Re: New Industrial Live/Work (**MLDFY2023-0002**)
Plan Review and City Engineer Comments

Thank you for the review on the above referenced project. The following represents our response to the plan review comments:

L1.0

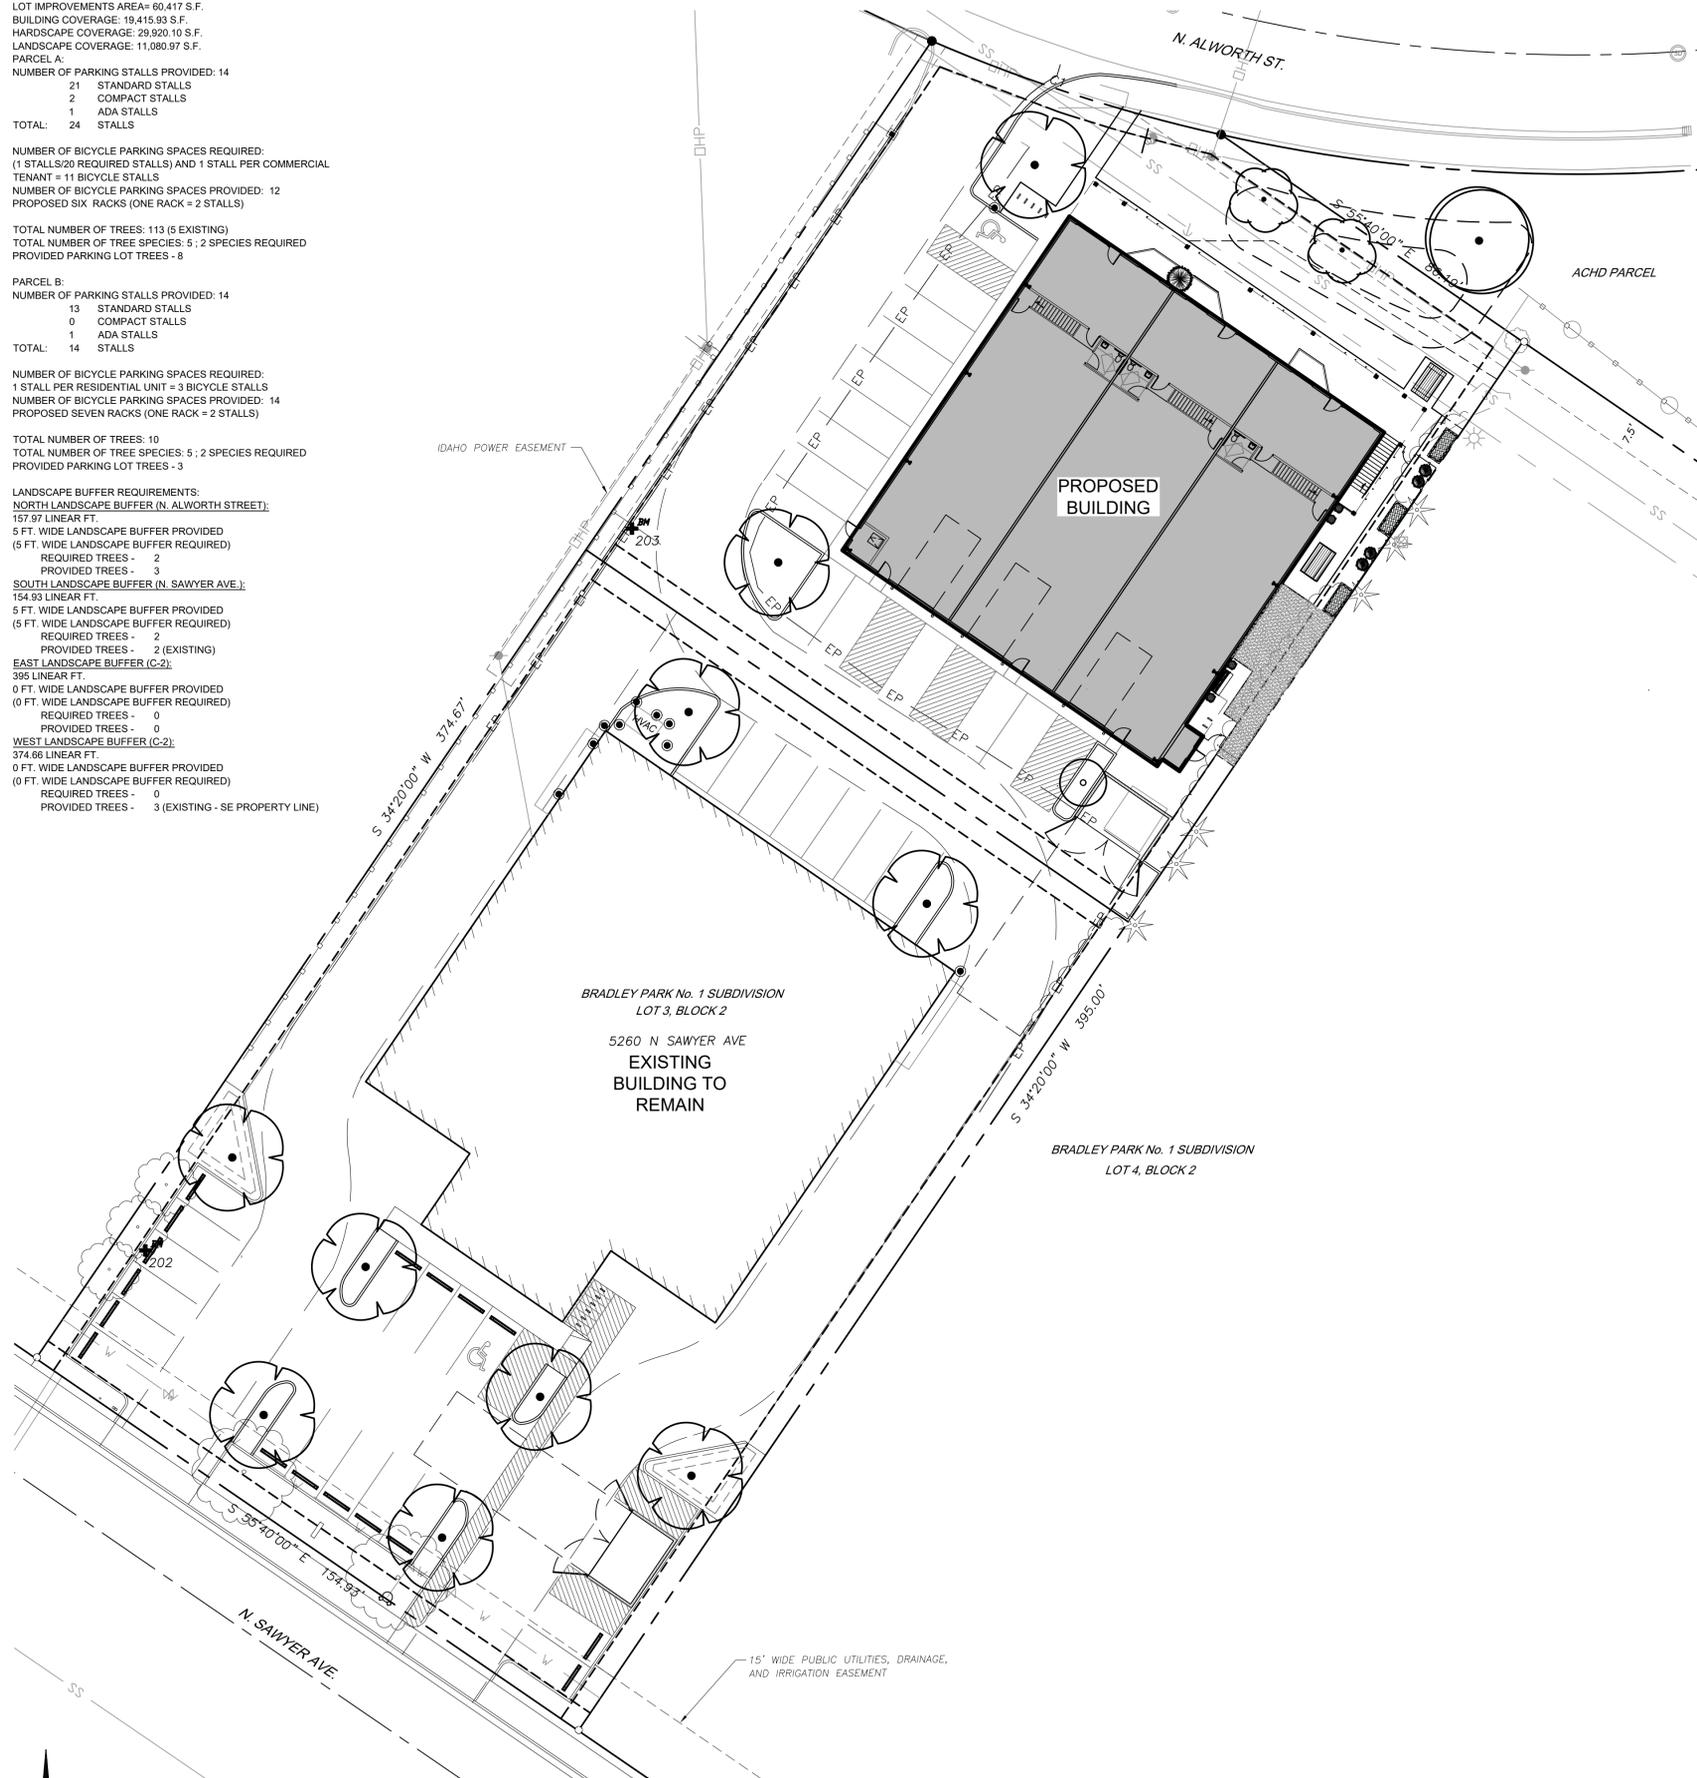
Item 4: *Address whether a pressurized irrigation system will be installed or a waiver request to this requirement will be submitted.*

- Item 11: *New landscape plans shall be submitted showing compliance with Garden City Code 8- 4I-4.*
a. A minimum of two additional Class II or III trees shall be planted in the frontage of N. Sawyer Ave.
b. A minimum of one tree per 1,000sqft of landscaped area and one shrub per 150sqft of landscaped area shall be planted.

Response: A pressurized irrigation system will be provided for both parcels. See L1.0 Landscape Plan for notes in regard to irrigation.

Response: See new sheets L1.0 and L1.1 for landscaping plans showing compliance with GC Code 8-4I-4 and addressing requirements associated with previous CUP96-06-06 approval.
